Re: Response to Transportation Peer Review
Proposed Multifamily Residential Development – 55 West Union Street
Ashland, Massachusetts

Vanasse & Associates, Inc. (VAI) is providing responses to the comments that were raised in the November 13, 2025 *Transportation Peer Review* memorandum prepared by Howard Stein Hudson (HSH) concerning their review of the June 2025 *Transportation Impact Assessment* (the “June 2025 TIA”) and the accompanying Site Plan and associated materials that were prepared in support of the proposed multifamily residential development to be located at 55 West Union Street in Ashland, Massachusetts (hereafter referred to as the “Project”). Listed below are the comments that were identified by HSH in the subject memorandum followed by a response by VAI or the appropriate member of the Project team on behalf of the Project proponent.

PARKING LAYOUT PLAN

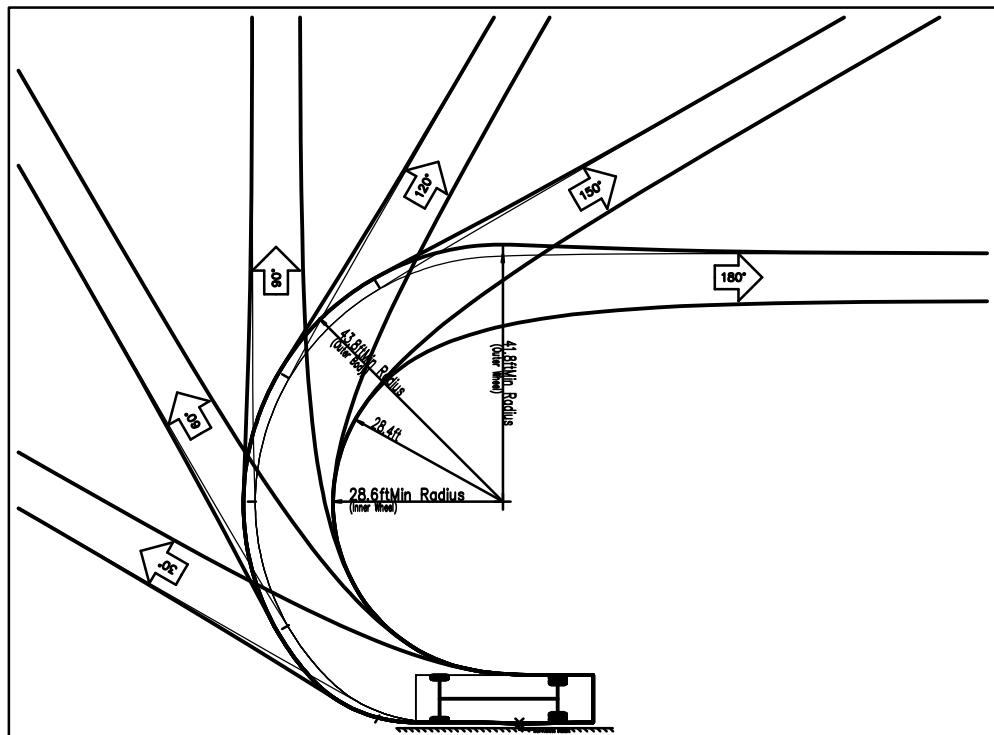
Comment: As previously mentioned, HSH has reviewed the materials contained within the 55 West Union Street Proposed Site Plan Set, Ashland, MA prepared by Connorstone Engineering Inc. Sheet 5 – Parking Layout Plan of the proposed Plan Set indicates 184 total spaces will be provided, including 19 for visitors. The Parking Layout Plan also indicates that all parking spaces measure 9 feet in width and 18 feet in length. The Town of Ashland's Zoning Code requires a minimum of 232 parking spaces on-site for residential use.

Additionally, Sheet 5 – Parking Layout Plan of the proposed Plan Set indicates a designated area for drop-off/pick-up under a covered entry on the northeast side of the Project site and a “Loading Area” west of the of East Project Site Driveway.

HSH Comment: *HSH notes the area of snow storage is proposed to be located in front of numerous residents and visitors parking spaces on-site. HSH requests the Applicant clarify how snow removal vehicles will access the snow storage locations when all parking spaces are occupied.*

HSH Comment: *HSH generally agrees with the proposed on-site pedestrian and bicycle accommodations; however, at the East Project Site Driveway, a short sidewalk is provided on the west side of the driveway that terminates at the Loading Area. HSH recommends providing a crosswalk between this sidewalk and the sidewalk in front of the building, as well as installing warning signage and/or an audible alarm for vehicles exiting the Loading Area.*

Comment: **HSH Comment: HSH requests the Applicant provide a plan indicating the location of the indoor bicycle parking and confirm the number of bicycle spaces to be accommodated. HSH also requests the Applicant identify on the Site Plan the proposed outdoor bicycle racks.**

HSH Comment: HSH requests the Applicant provide a signage and pavement marking plan that includes all the appropriate crosswalk locations throughout the proposed Site, including the two proposed driveways.

VAI Response: The subject sidewalk segment will be relocated to the east side of the driveway to better align with the pedestrian entrance to the building and a crosswalk with accompanying ADA compliant wheelchair ramps will be provided to link the sidewalk to the proposed building.

VAI Response: Bicycle parking will be provided on the ground floor of the building in a bicycle room that will be accessible from the lobby area as shown on Drawing A-101 of the Architectural Drawings (attached). The bicycle room has been designed to accommodate 44 bicycles. Exterior bicycle racks have been added to the Site Plan (also attached).

VAI Response: Signs and pavement markings have been added to the Site Plan.

SU-30 DELIVERY TRUCK - SWEEP PATH
OF
55 WEST UNION STREET
IN
ASHLAND, MA

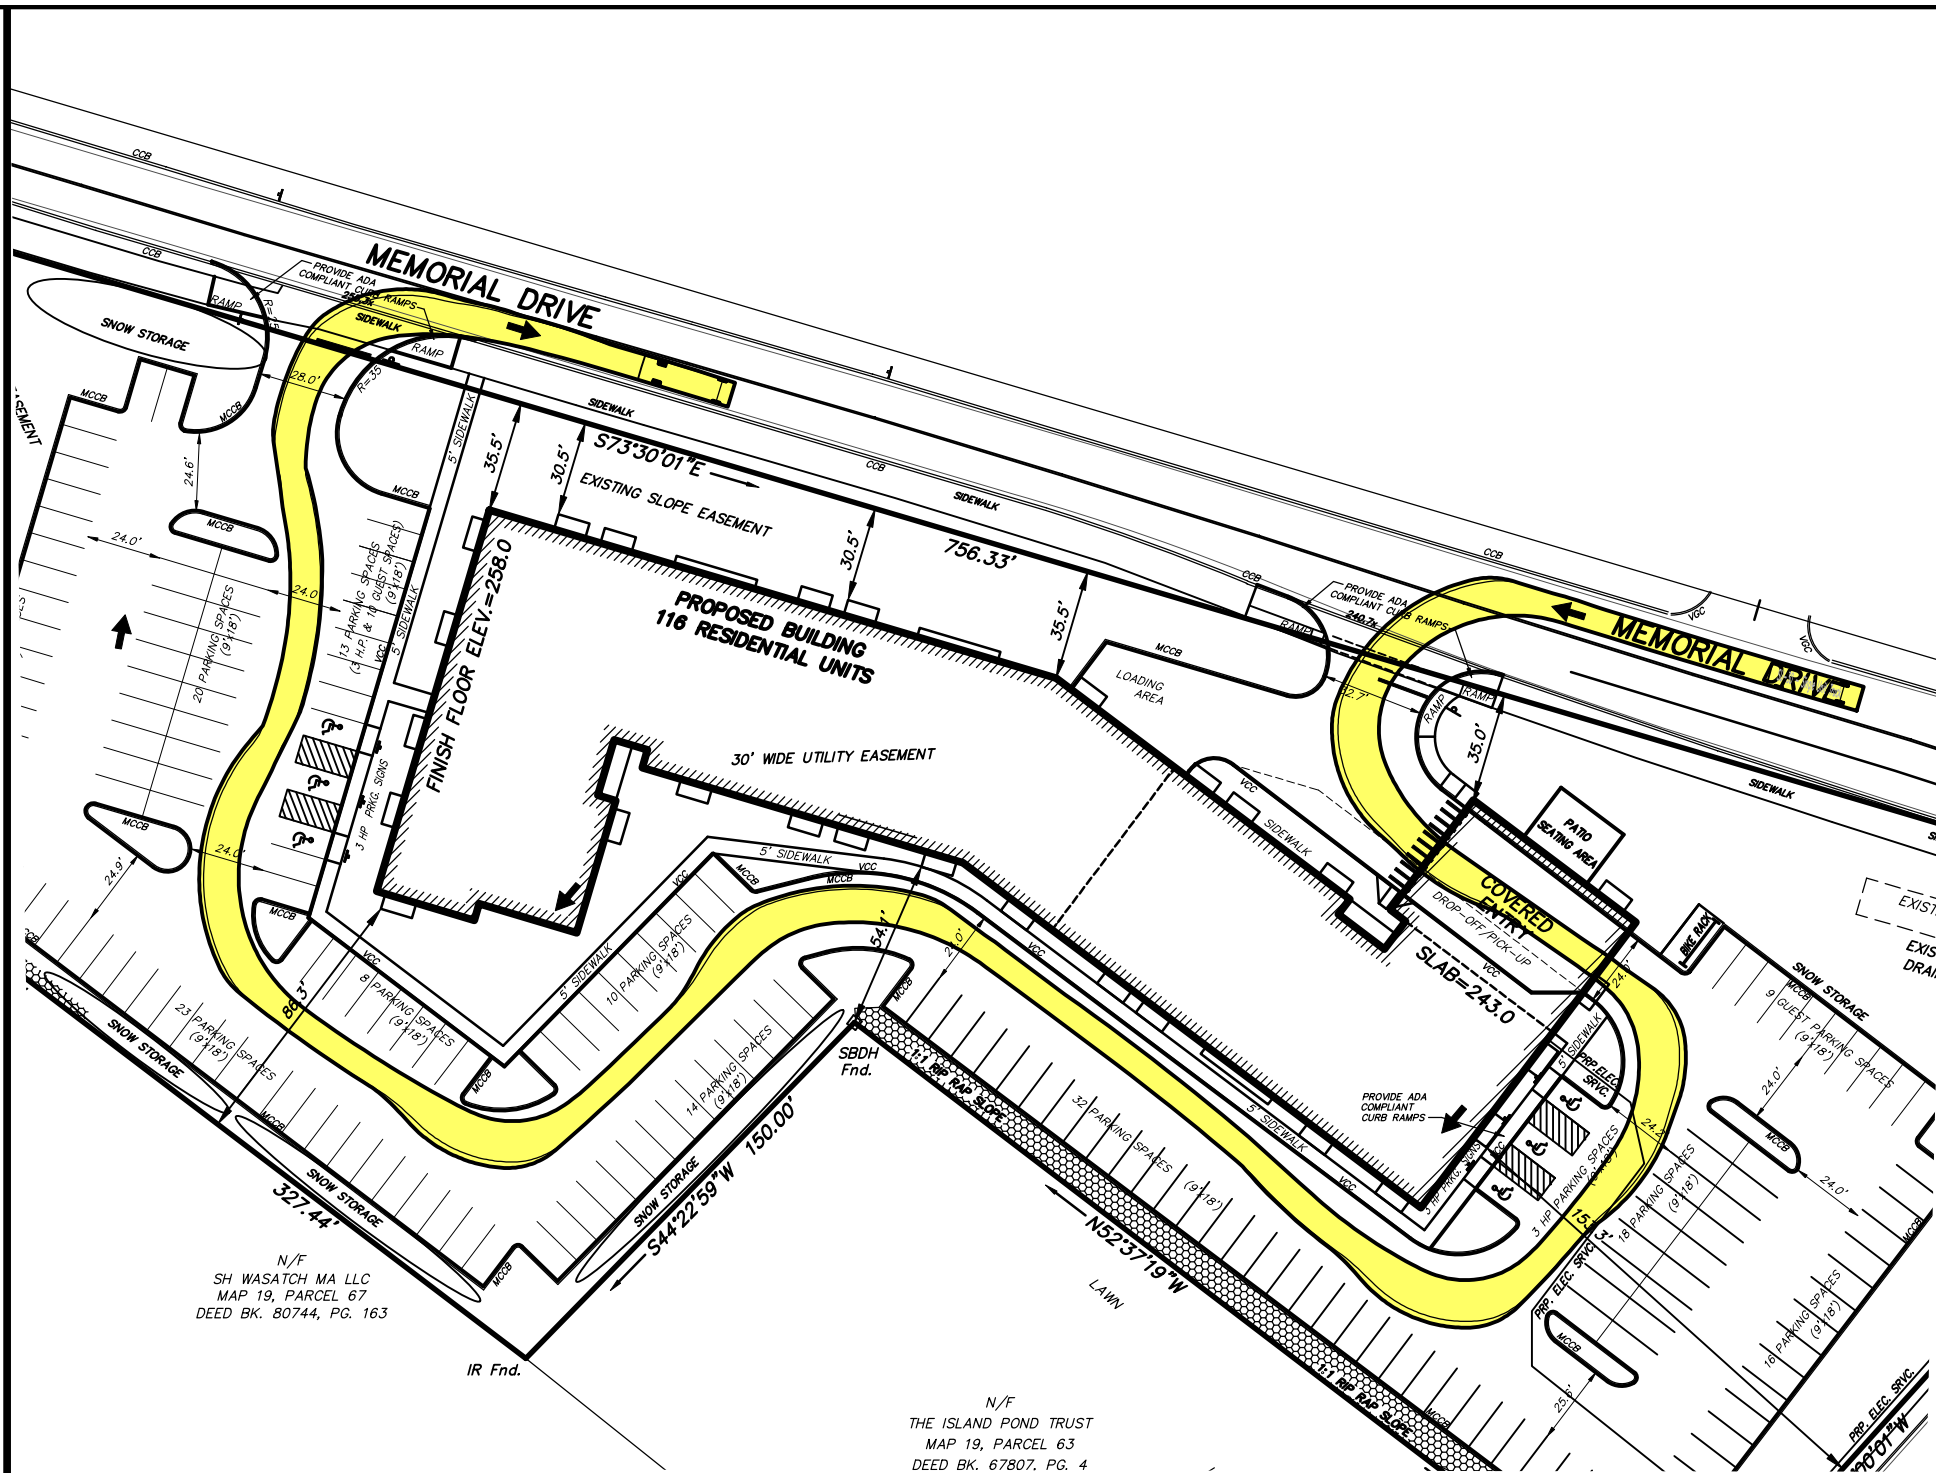
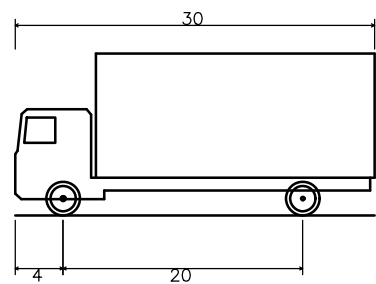
HSH Comment: *HSH generally agrees with the site access recommendations made by the Applicant. However, the Applicant does not provide sufficient information on loading and trash/recycling accommodations. HSH requests the Applicant provide a detailed plan as to where move-in/move-out activity will take place, including a comprehensive AutoTURN analysis to demonstrate that all anticipated vehicles (moving, delivery, and trash/recycling trucks) can safely circulate the site and the designated loading area.*

Response: **As requested, a vehicle turning analysis has been prepared and is attached to verify anticipated vehicle circulation through the site and/or access to loading area. The loading/trash area is located to the west side of the main access and has been shown to accommodate the required movements of a garbage truck (SU-40). Delivery vehicles and moving vans (SU-30), which would access near the covered entry, have also been shown to have sufficient space to circulate through the entire site.**
